## PRODUCT/PROCESS CHANGE NOTICE (PCN)

PCN #: <b>L-0607-01R1</b> Product Affected: <b>Please see the attached list of the affected products shipped in tape and reel, and in tubes</b> Date Effective: <b>6-Oct-06</b>	DATE: <b>6-Oct-06</b>	MEANS OF DISTINGUISHING CHANGED DEVICES: <input type="checkbox"/> Product Mark <input type="checkbox"/> Back Mark <input checked="" type="checkbox"/> Date Code <input type="checkbox"/> Other Lot shipments will have Level 1 Moisture Sensitive Label, and with date code starting "0630".
---	-----------------------	---

**PCN Type:** Change in Moisture Sensitivity Level

**Detail of Change:**

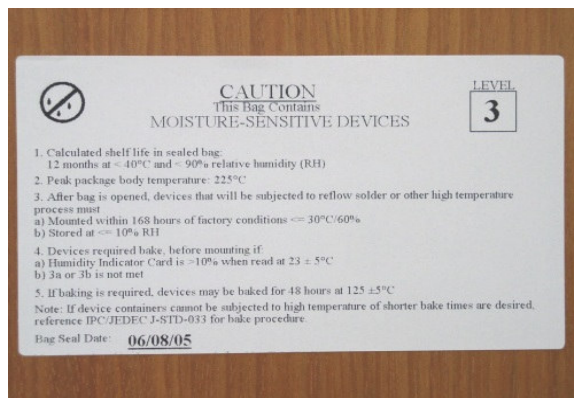
**Data Sheet Change:** There is change in Moisture Sensitive Level (MSL) from 3 to 1.

This notification is to advise customers that IDT is converting ICS MSL 3 products shipped in tape and reel, and in tubes, to MSL 1. IDT has completed the verification of the moisture sensitivity classification of ICS products to MSL 1.

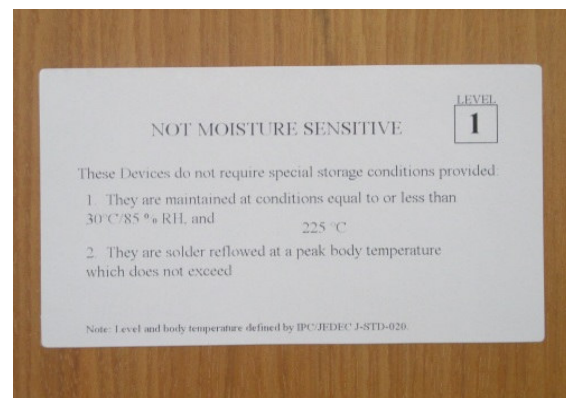
The affected products will be shipped without dry pack and labelled as MSL 1 according the JEDEC J-STD-033. There is no change to the assembly material set and the peak reflow temperature. Please refer below for the examples of moisture sensitive labels.

**From: MSL 3 Moisture Sensitive Label**

**To: MSL 1 Non-Moisture Label**

**Note: There is no change to the peak reflow temperature of the affected products.**
